Addendum No. 1
9/7/2023

Re-Bid Dodgen Research Facility
Nuclear Science Center HVAC Renewal
Washington State University
Pullman, WA

Project No.1687-2022
Washington State University
Facilities Services, Capital

PRE-BID MEETING

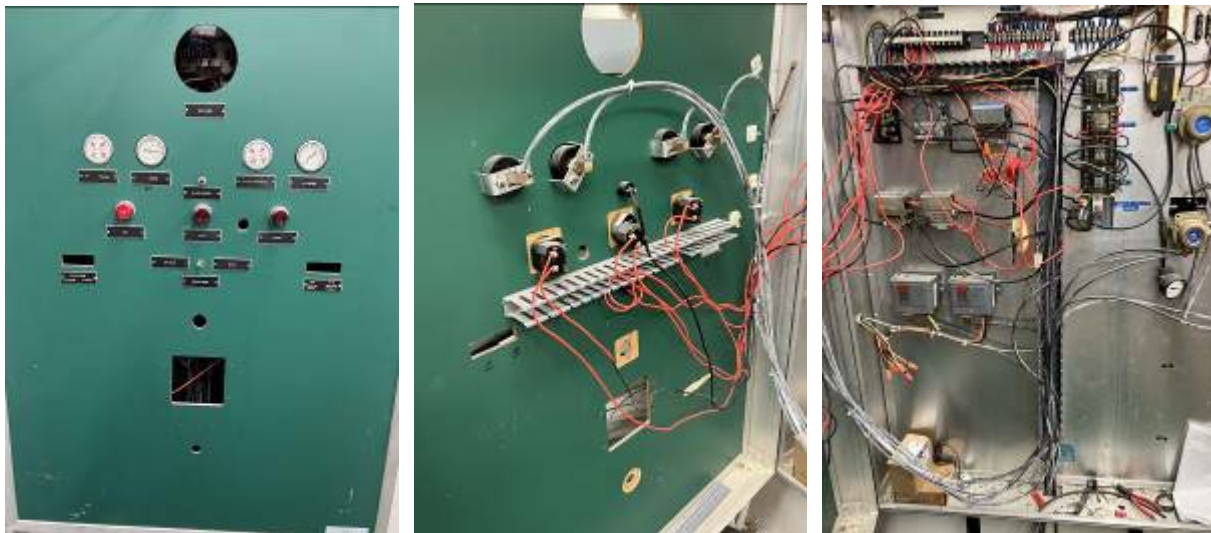
1. E-601, the pilot lights that are shown (also on the following page) will all come on because they are all tied together to PB1. Is the intent for PB1 to be a “test light”? Could we instead buy PTT pilot lights and wire them for push to test?
 - a. **The intent of PB1 is to test all of the LED/lights with a single test button.**
2. E-602, For the Display Graphic, can we get dimensions? How tall and wide is the plate? How much depth between the back of the graphic and the panel behind it that the terminal blocks will be mounted to?
 - a. **The display is on a standard rack 19” wide by 14” tall. Depth available for use is 16”. Color needs to match existing. See photo below.**
